# Railyards Specific Plan Update, KP Medical Center, MLS Stadium, & Stormwater Outfall

Final Subsequent Environmental Impact Report

P15-040 | SCH No. 2006032058

October 2016

Sacramento Railyards Specific Plan Update . 150286  
**Figure 2-37**  
 MLS Stadium Site Amplified Sound Plan

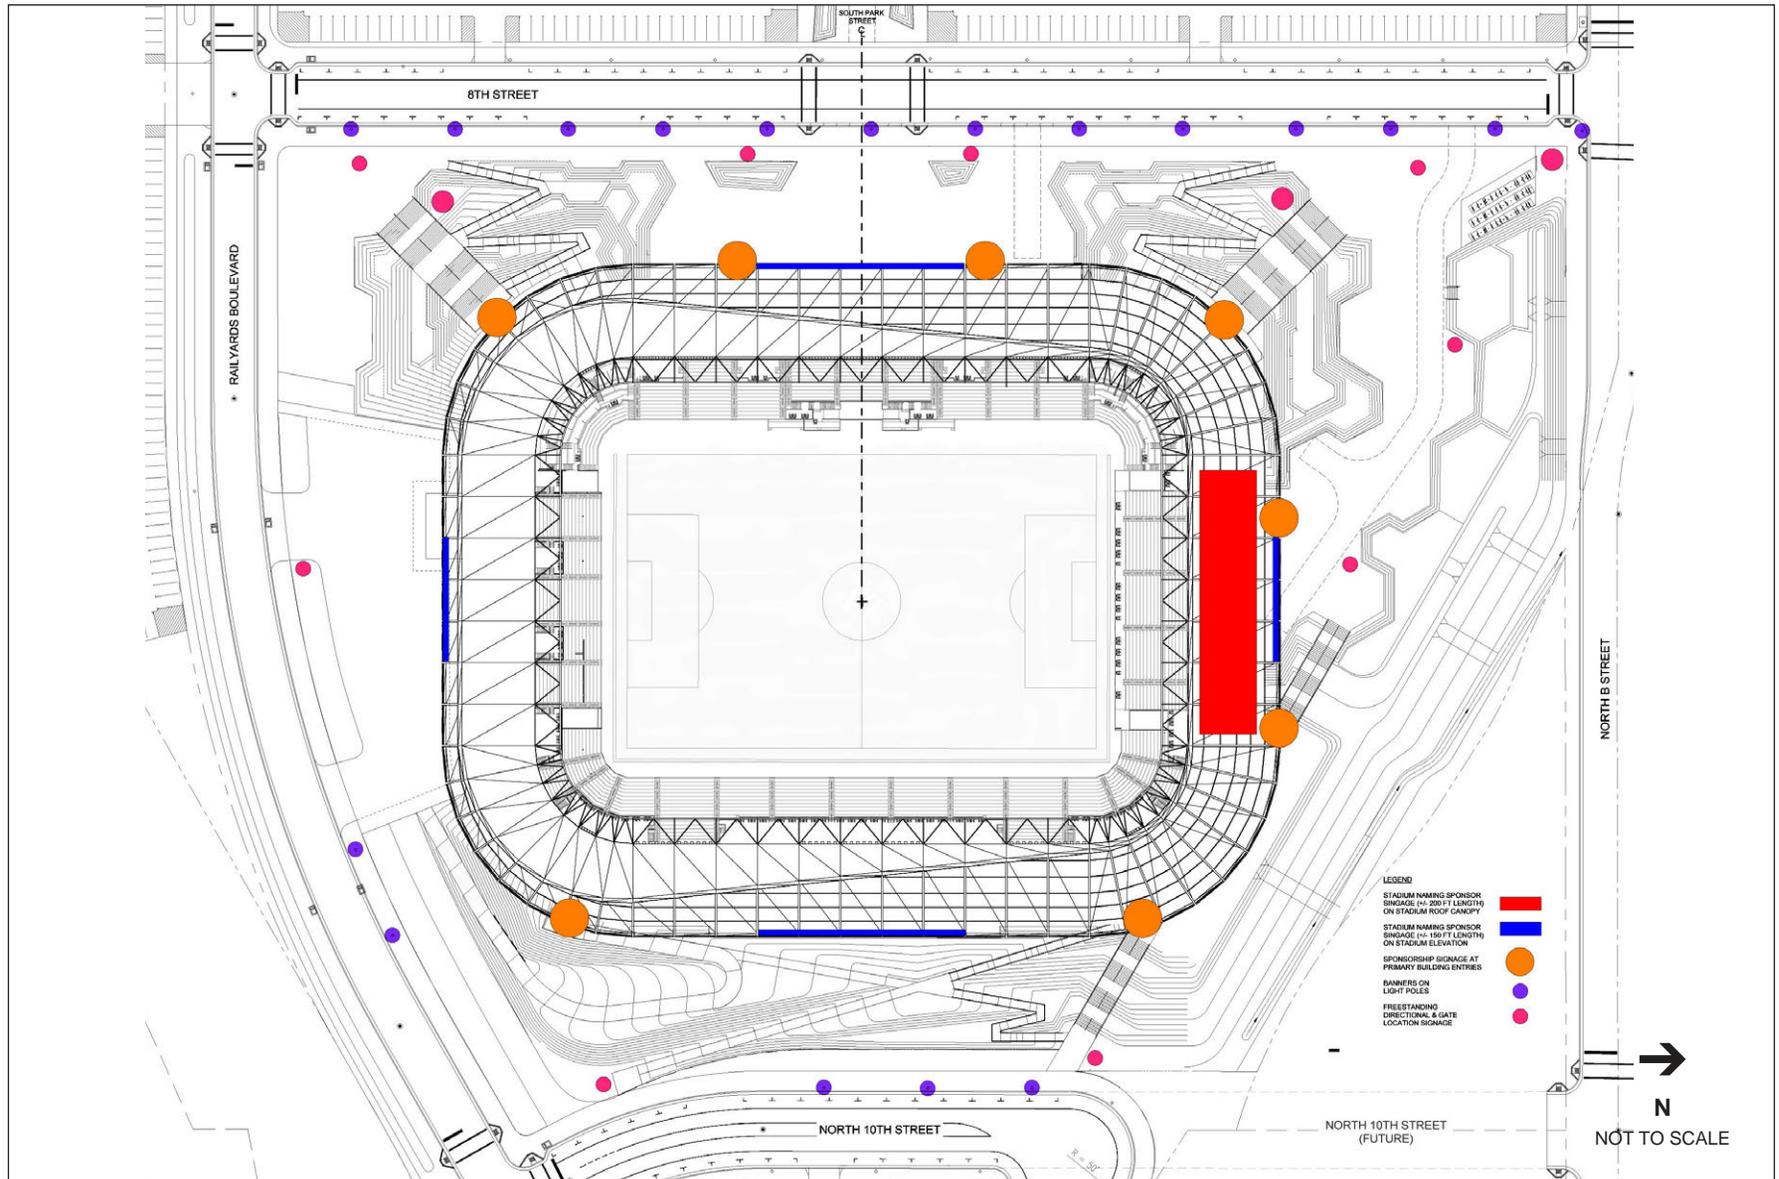
Figure 2-37, MLS Stadium Site Amplified Sound Plan, is revised to show the revised MLS Stadium location moved approximately 40 feet to the north. Localized amplified public address speakers are shown at the primary MLS Stadium entrances.

**Figure 2-38**  
Stadium Signage Plan

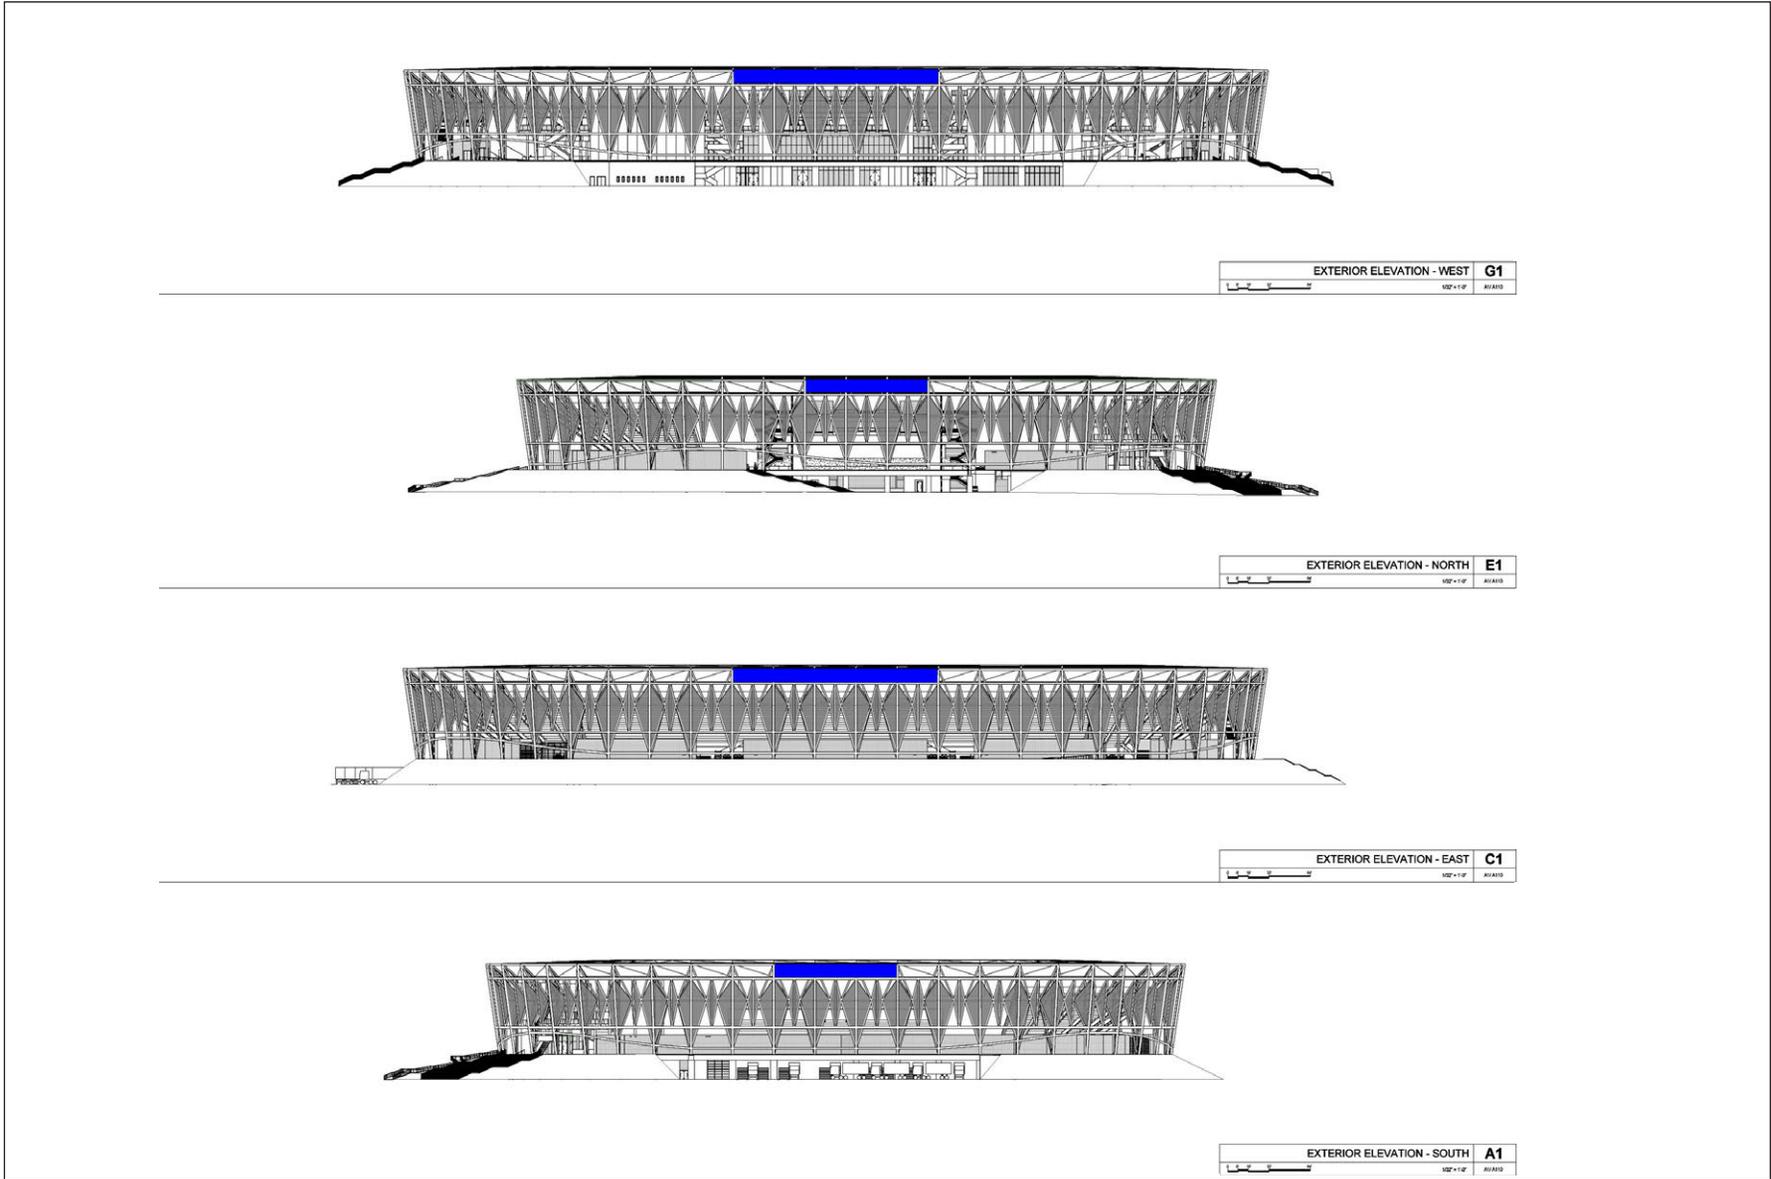
Figure 2-38, Stadium Signage Plan, is revised to show the revised MLS Stadium location moved approximately 40 feet to the north. Previously proposed signage pylons were removed from the

**Figure 2-39**  
MLS Stadium Naming Sponsor Signage Elevations

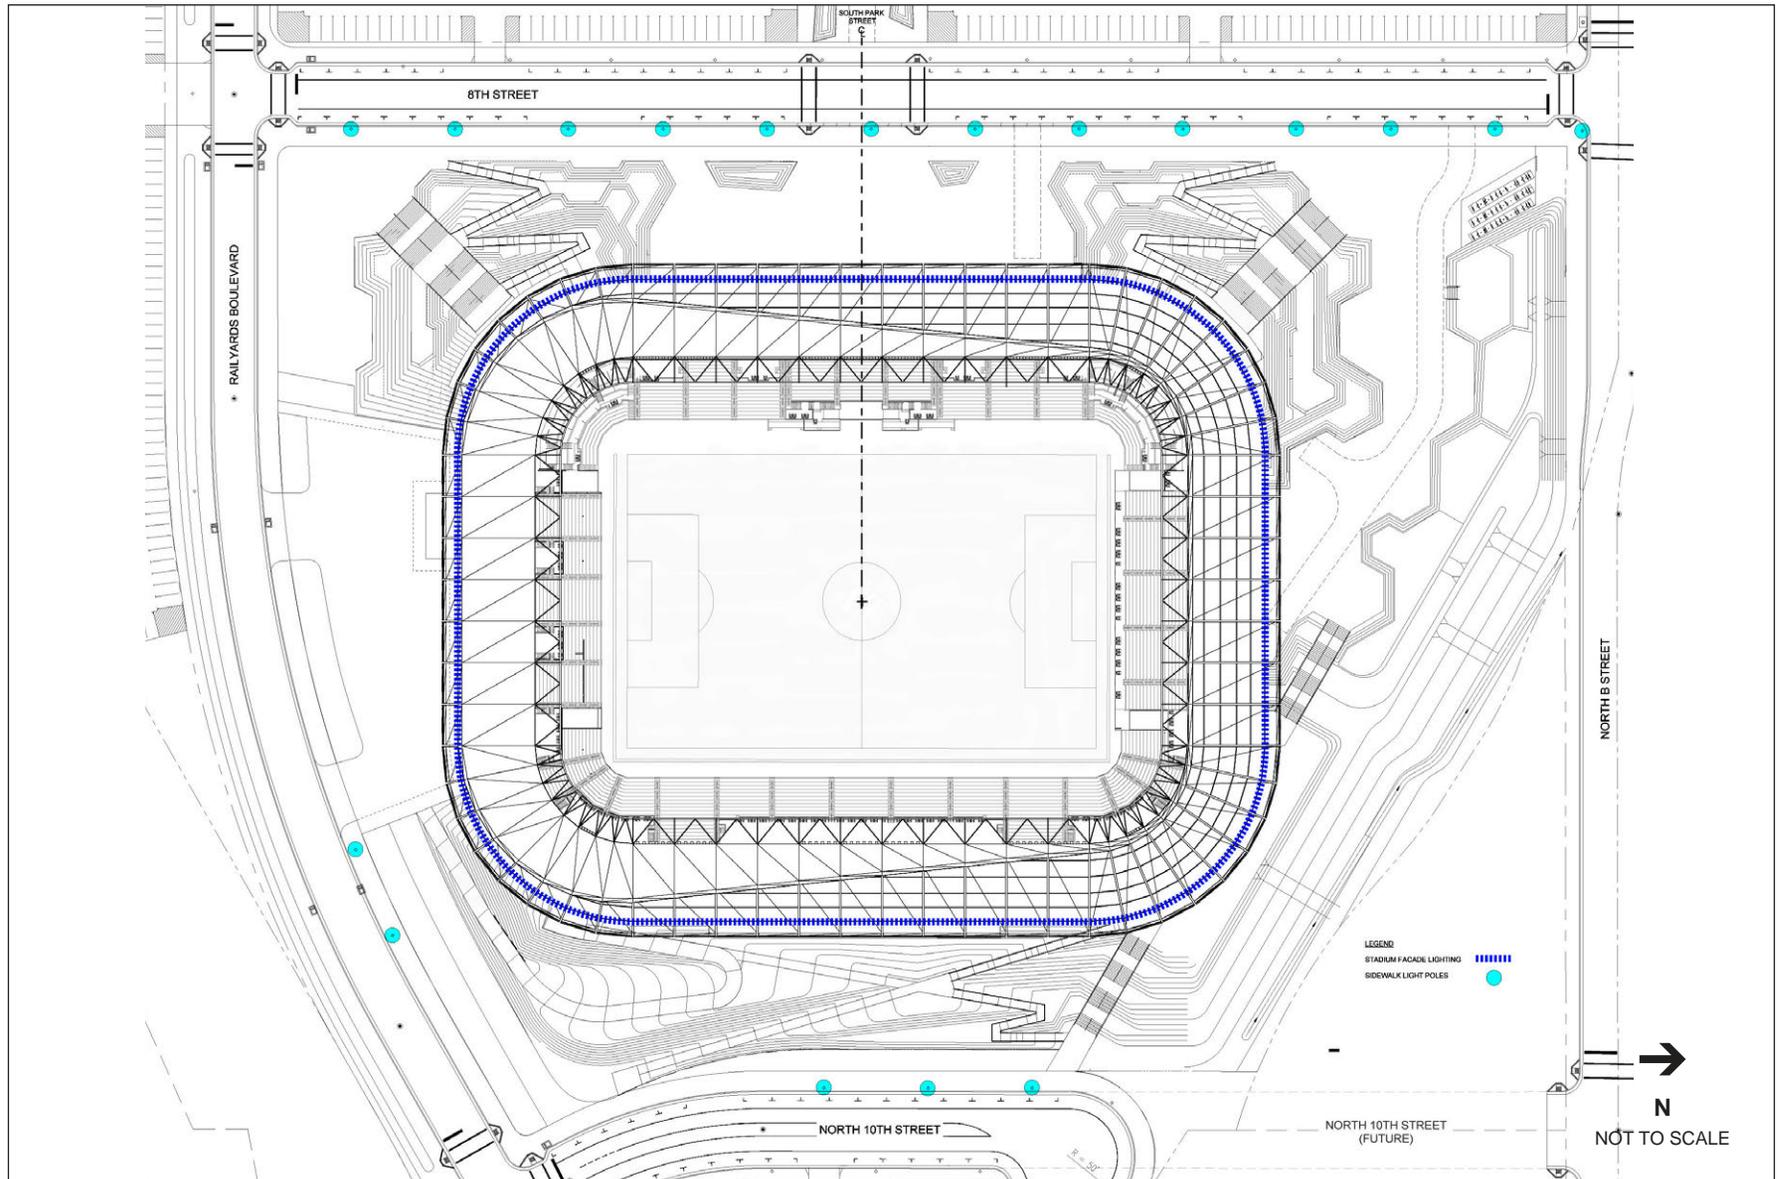
Figure 2-39, MLS Stadium Naming Sponsor Signage Elevations, is revised to show the revised MLS Stadium location moved approximately 40 feet to the north. The proposed MLS Stadium naming sponsor signage on the east and west facades of the MLS Stadium were reduced in length from approximately 200 feet to approximately 150 feet.

**Figure 2-40**  
Stadium Lighting Plan

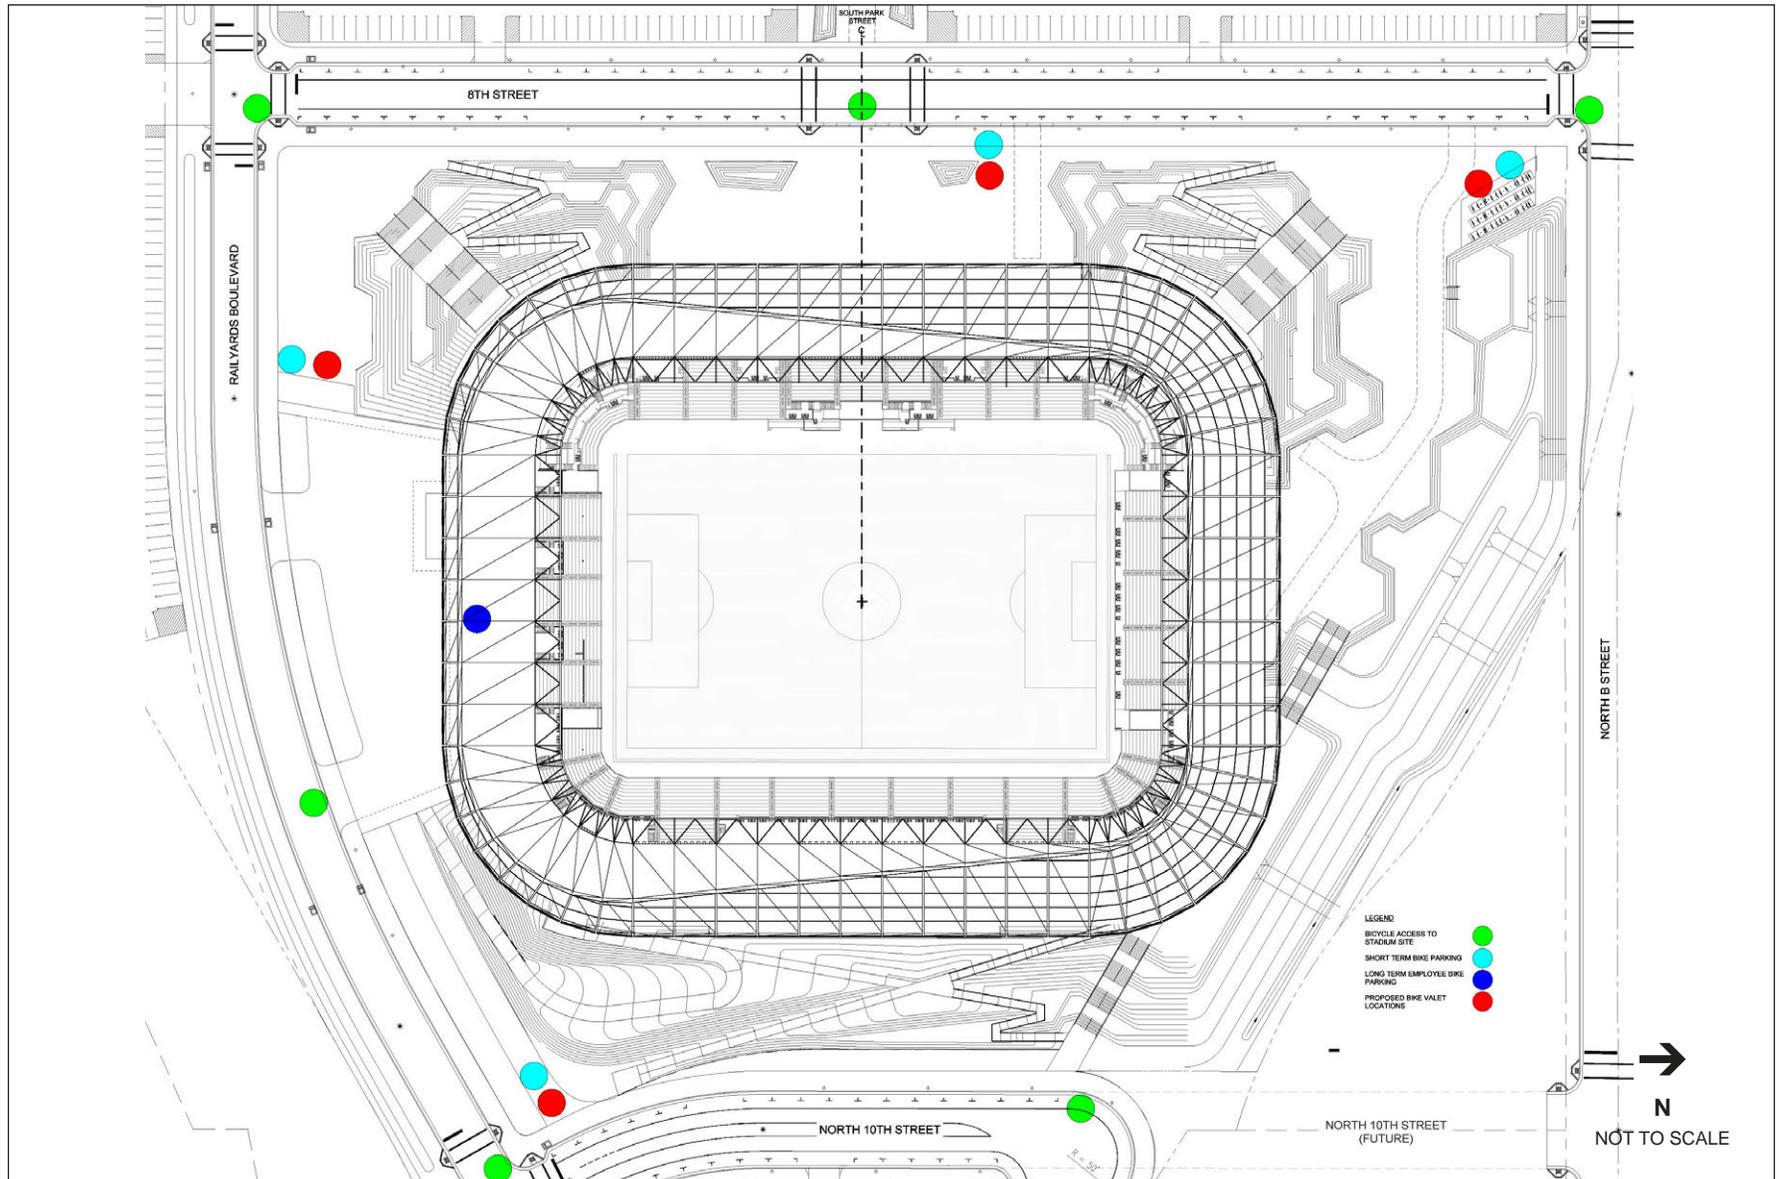
Figure 2-40, Stadium Lighting Plan, is revised to show the revised MLS Stadium location moved approximately 40 feet to the north. The lighting plan also shows Stadium façade lighting around the perimeter of the stadium.

**Figure 2-41**  
MLS Stadium Bicycle Plan

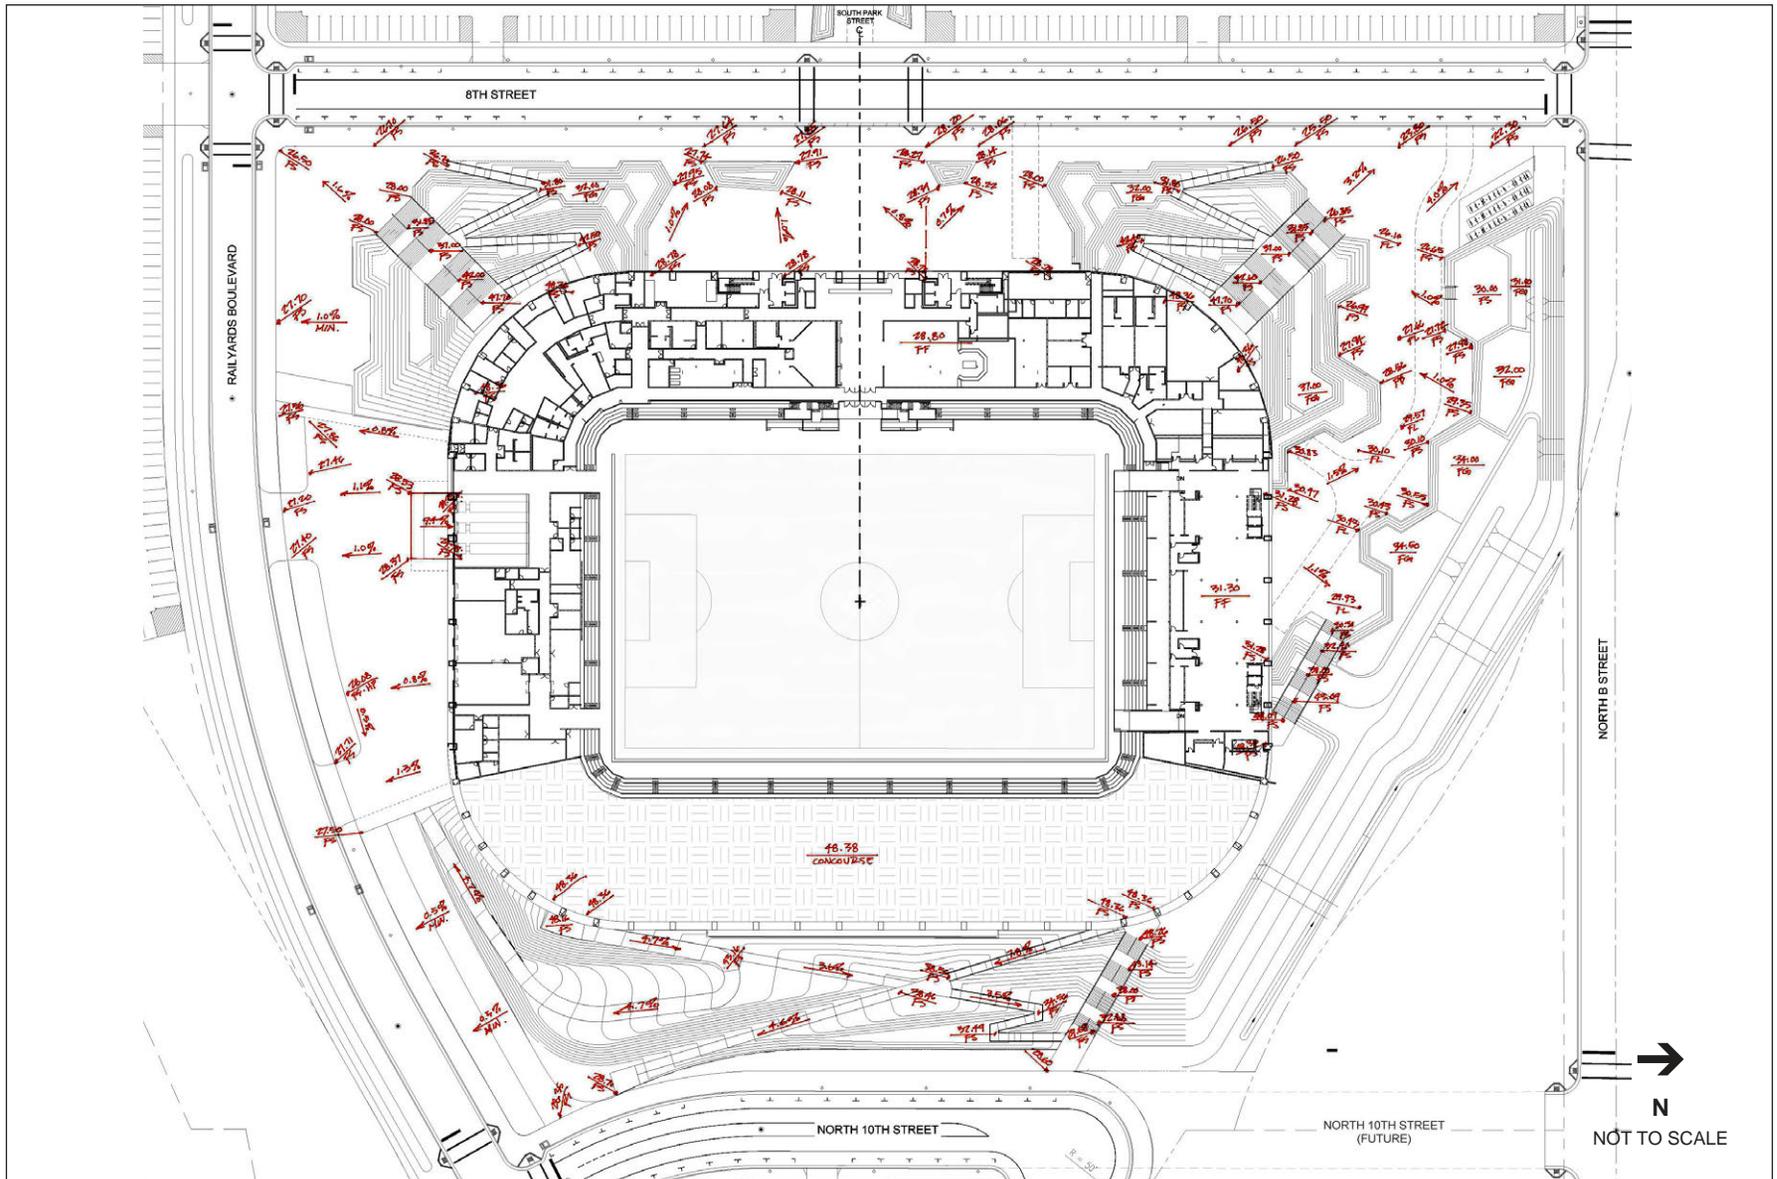
Figure 2-41, MLS Stadium Bicycle Plan, is renamed to clarify that the bike plan is specific to the MLS Stadium. The figure is revised to show the revised MLS Stadium location moved approximately 40 feet to the north. Additional details are provided showing the locations of bicycle access to the MLS Stadium site, short term bike parking, long term employee bike parking, and proposed bike valet locations.

We heartedly support the Stadium Bicycle Plan shown in Figure 2-41; it is quite robust in depicting proposed points of bicycle access to the stadium site and bicycle parking locations (including short-term, long-term, and valet for large events).
